Central Planning Authority

Agenda for a meeting of the Central Planning Authority to be held on **January 18, 2023 at 10:00am in Conference Room 1038, 1st Floor, Government Administration Building, and Elgin Avenue.**

CPA/02/23

Figure 1: Aerial imagery showing the site before it was cleared with the 50 ft setback line (red) 75 ft setback line (yellow) and the proposed development footprint (orange) (LIS 2004).

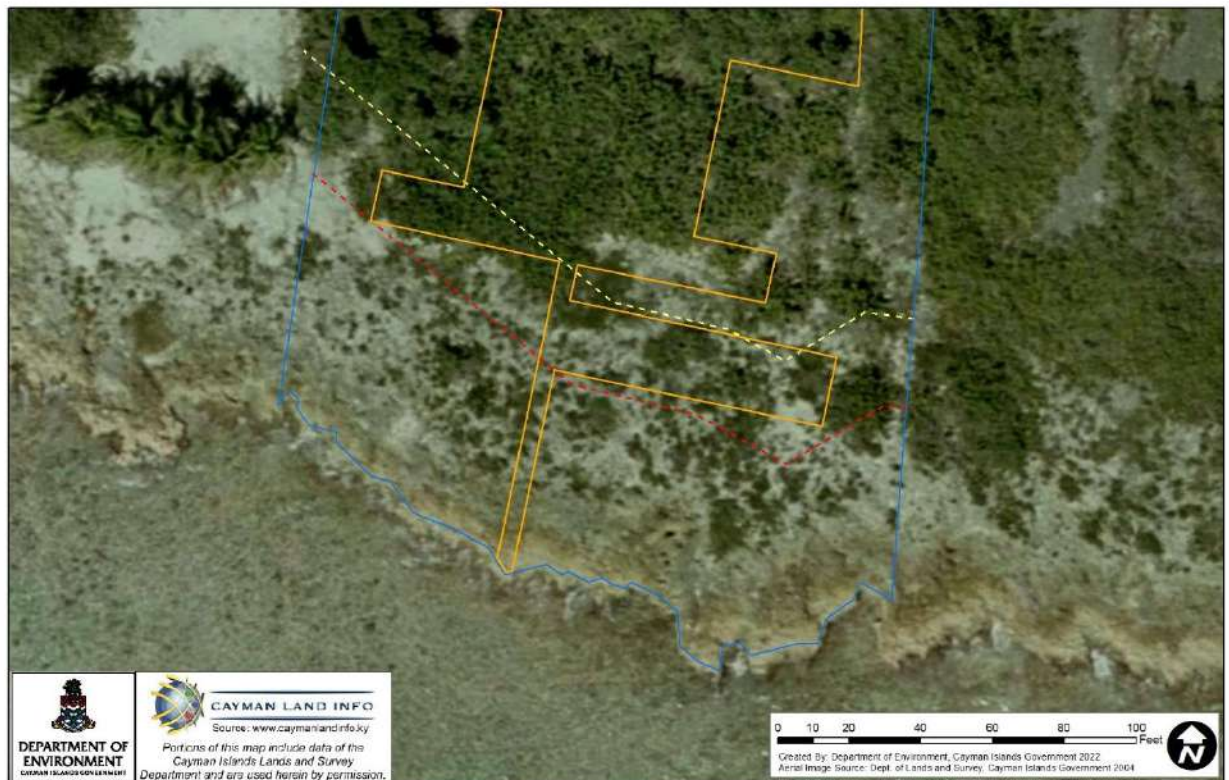
The Department of Environment is also concerned about the proposed coastal setbacks of 50 ft for this development given that this coastline is very exposed, due to the lack of significant offshore reef protection, and therefore susceptible to wave impacts during severe weather. This area of coastline is low lying ironshore where the natural vegetation line indicates that wave impacts reach further than the proposed 50 ft inland of the Mean High Water Mark (MHW), as shown in Figure 1 above. Coastal setbacks are particularly important given climate change predictions for the region and the increasing prevalence of severe storm events and coastal erosion associated with inappropriately sited development. The Department of Environment would therefore recommend that the application be revised in order to **increase the coastline setback of all structures to a minimum of 75 ft**. A 75 ft coastal setback would allow the positioning of structures at the point where they do not extend closer to the sea than the historical vegetation line and therefore will be less susceptible to wave impacts during severe weather.
